APPEAL SUMMARY

Appeal ID: 24537	Project Address: 546 NE 12th Ave
Hearing Date: 1/20/21	Appellant Name: Joe Echeverri
Case No.: B-009	Appellant Phone: 9714201120
Appeal Type: Building	Plans Examiner/Inspector: John Cooley, Nate Takara
Project Type: commercial	Stories: 2 Occupancy: A-1, A-2, A-3, A-4, B, E Construction Type: II-B, III-B, II-A
Building/Business Name: Benson Polytechnic High School	Fire Sprinklers: Yes - NFPA 13 throughout
Appeal Involves: Erection of a new structure, Alteration of an existing structure, Reconsideration of appeal	LUR or Permit Application No.:
Plan Submitted Option: pdf [File 1] [File 2]	Proposed use: High School

Portland Public Schools
**BENSON
POLYTECHNIC
HIGH SCHOOL
MODERNIZATION**

546 NE 12th Ave, Portland, OR 97232

SK 2

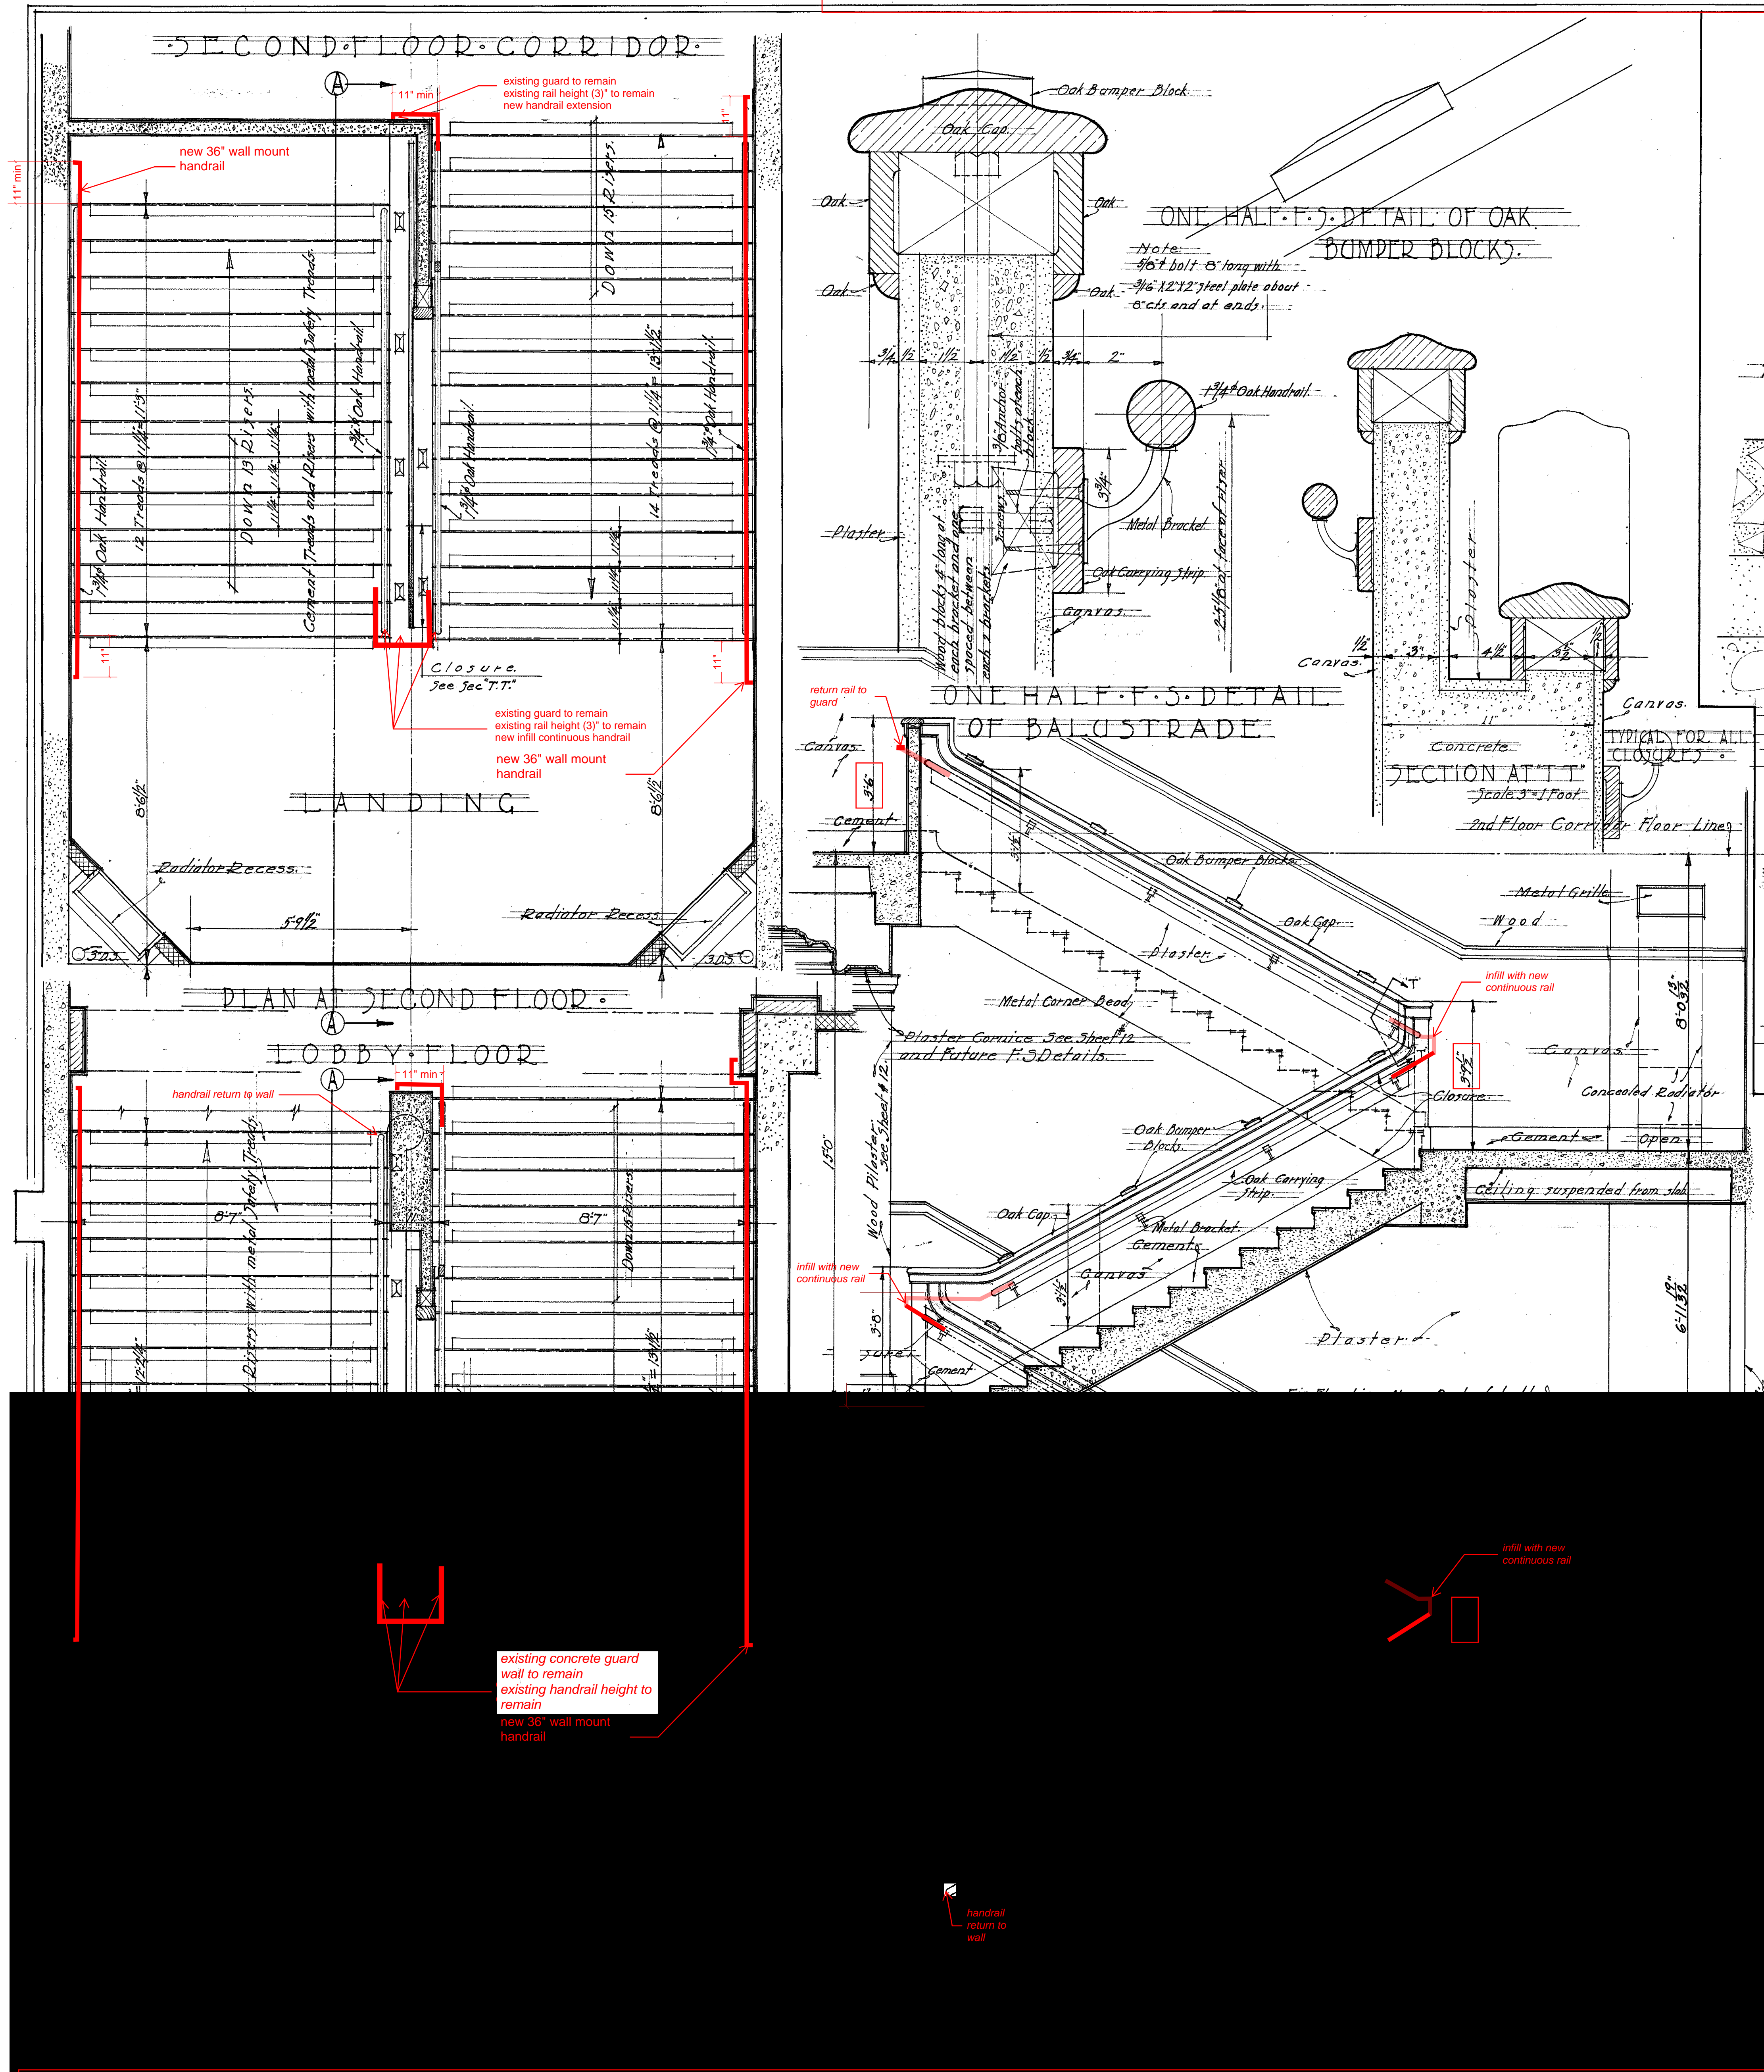
RECONSIDERATION: Existing wall mounted handrail height to remain at historic guard wall to maintain structural integrity of concrete wall. Add extensions top and bottom, where practical. Add continuous infill rail at stair mid-landings. Terminate handrail at level of exit discharge.

See exhibit pages SK2, SK3 and SK4 for rail heights, terminations, and continuity.

- Intermediate handrail height as-built 30" aff to remain.
- Install new perimeter wall handrail at 34 – 38" aff height.

- Intermediate handrail: Bottom terminate into guard less than 11". Top extend and wrap guard min 11"
- New perimeter wall handrail: Bottom and top extensions min 11" in direction of travel.

- Intermediate handrail on guard wall. Provide new infill 'continuous' handrail connecting existing rails between flights.

- 1. Reduction in minimum number of required plumbing fixtures: Granted as proposed.**
- 2. Existing handrail conditions to remain: Granted as proposed.**
- 3. Existing exit access stair configurations to remain with addition of quick response sprinkler heads: Granted as proposed.**
Note: Appeal also grants interior exit stairs 10 and 12 with quick response sprinkler protection on both sides of glazed walls. A separate permit from the Fire Marshal's Office is required.
- 4. Use of rail mounted ADA inclined platform stair lift for accessible route to two Level 2 classrooms at West side of Gymnasium: Granted as proposed with reduced stair width while lift is in operation.**
- 5. Omission of barrier where stairs continue below level of exit discharge: Granted as proposed.**
- 6. Allow existing historic guard rail heights to remain as built: Granted as proposed.**

SK 3

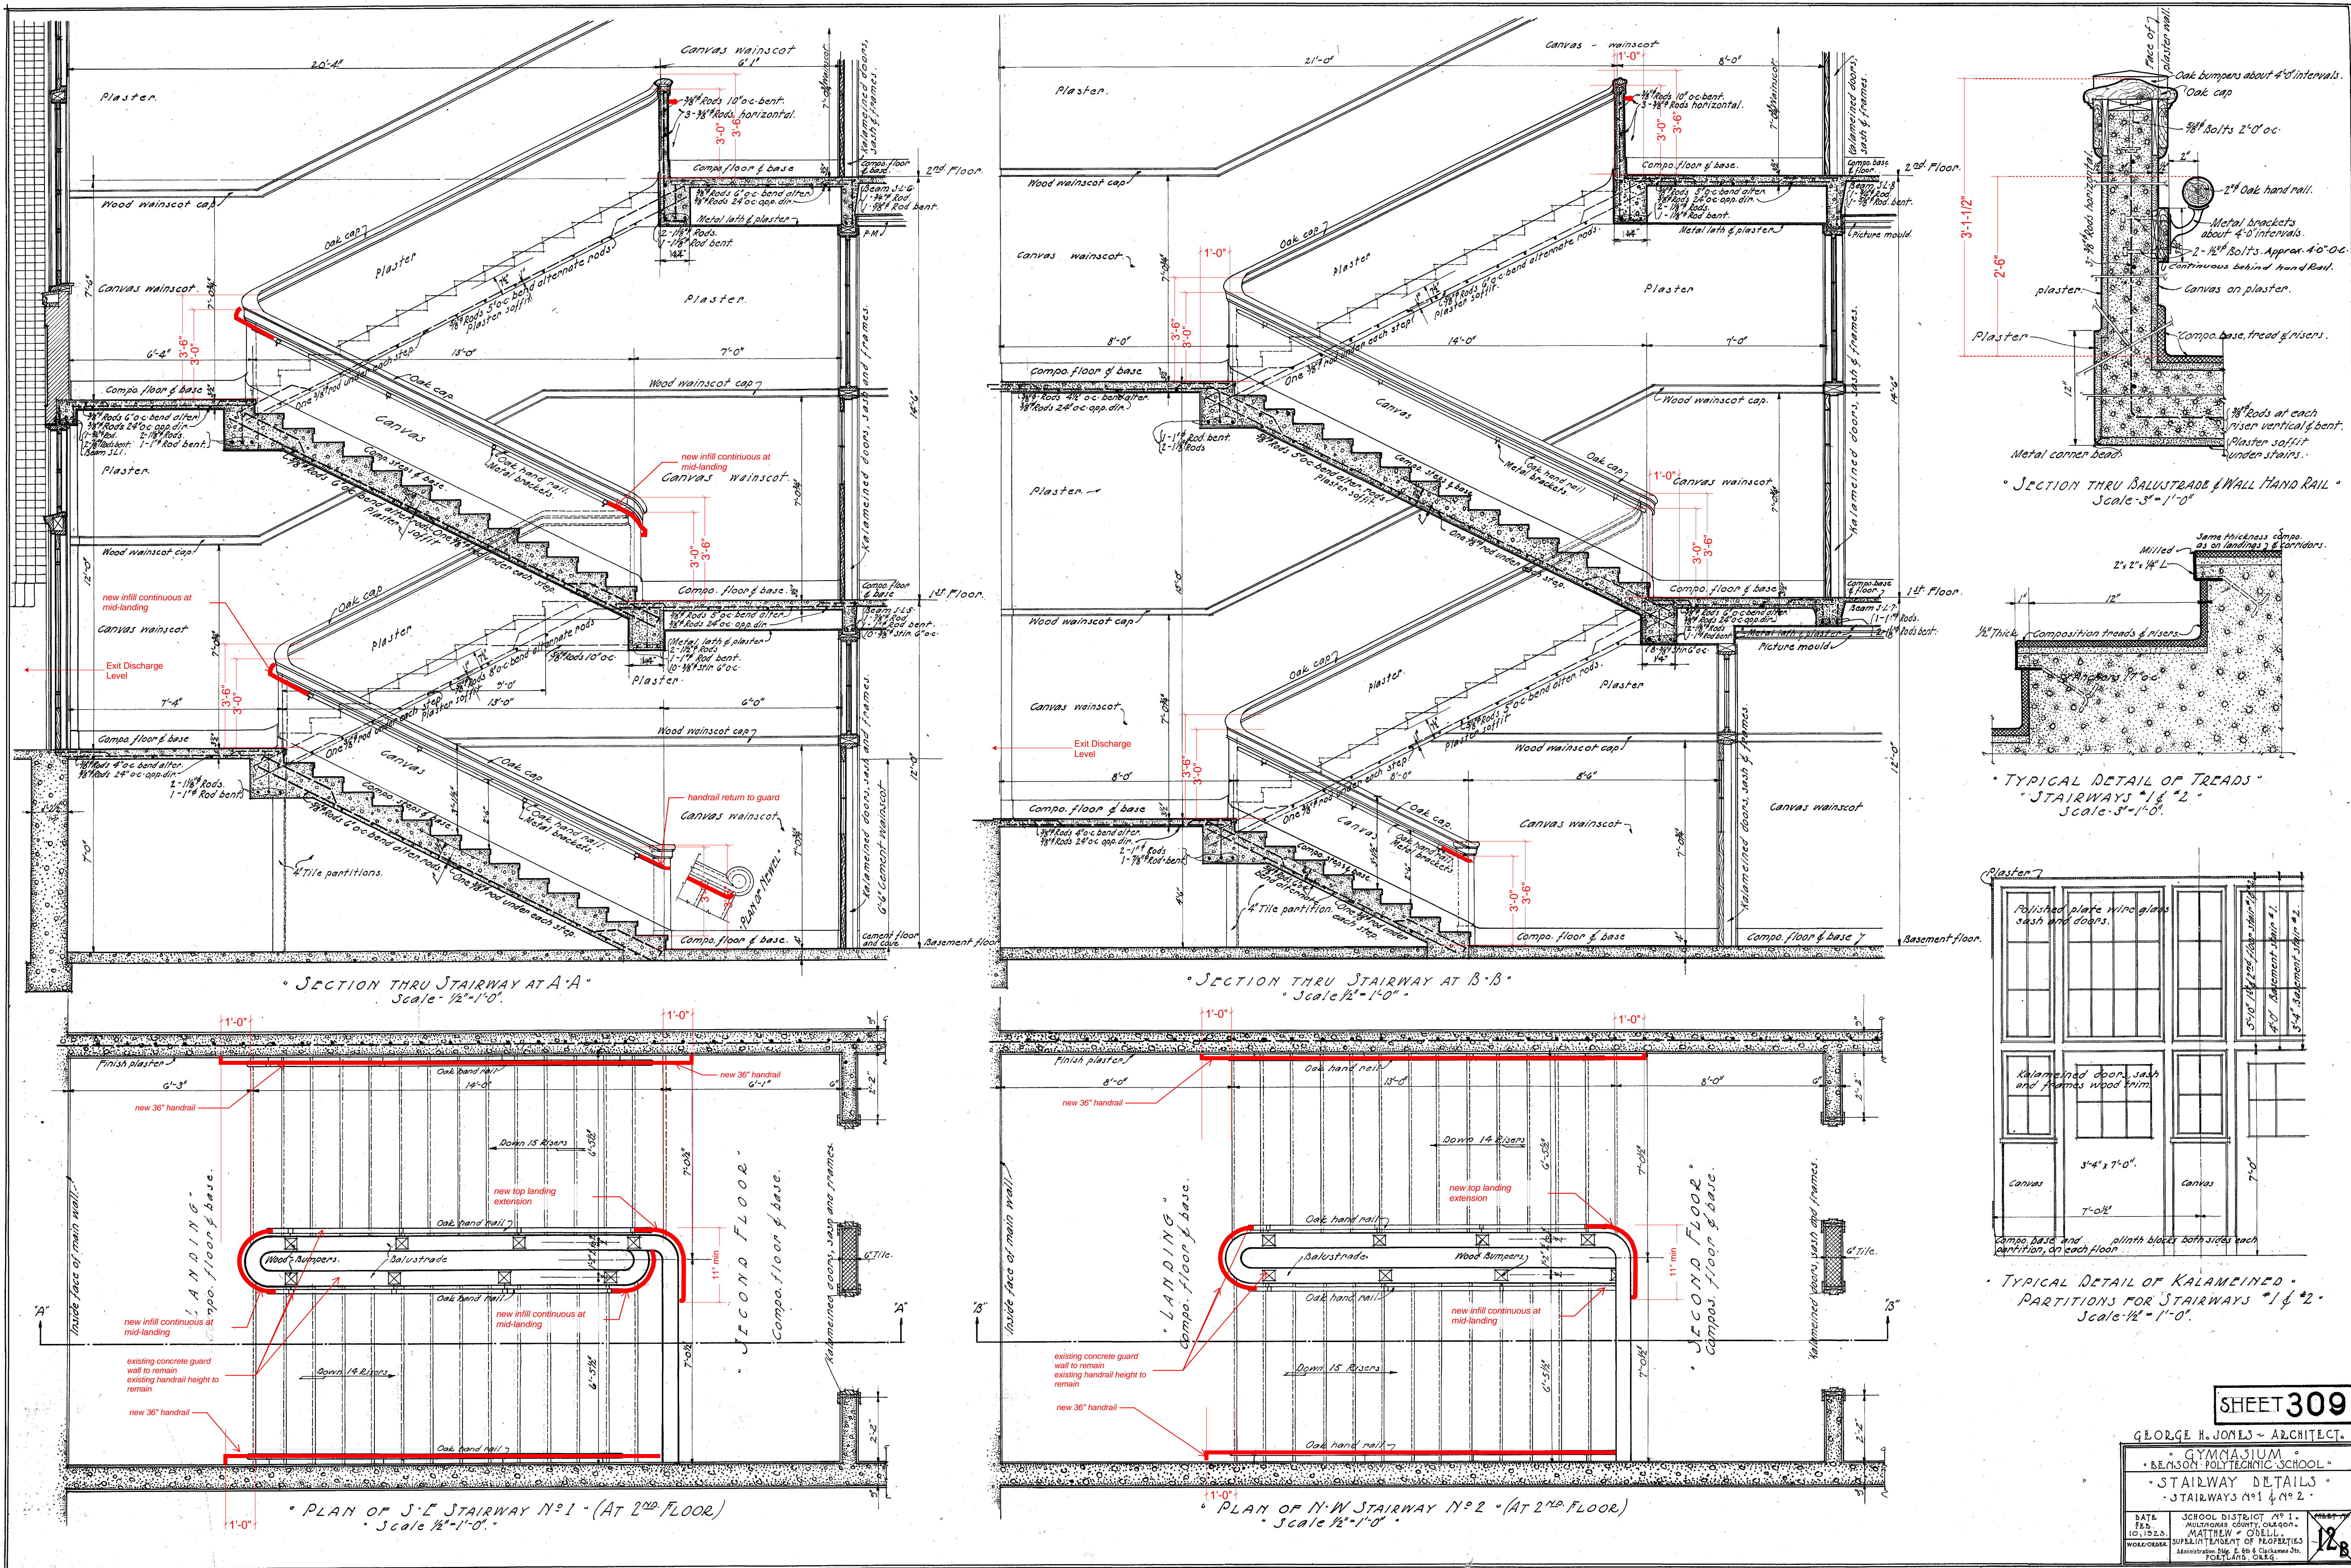
Locations: As indicated in initial appeal except Auditorium (Bldg. A) Delete Stair 4 guard. See SK2, SK3 and SK4 for historic building guard heights and details.
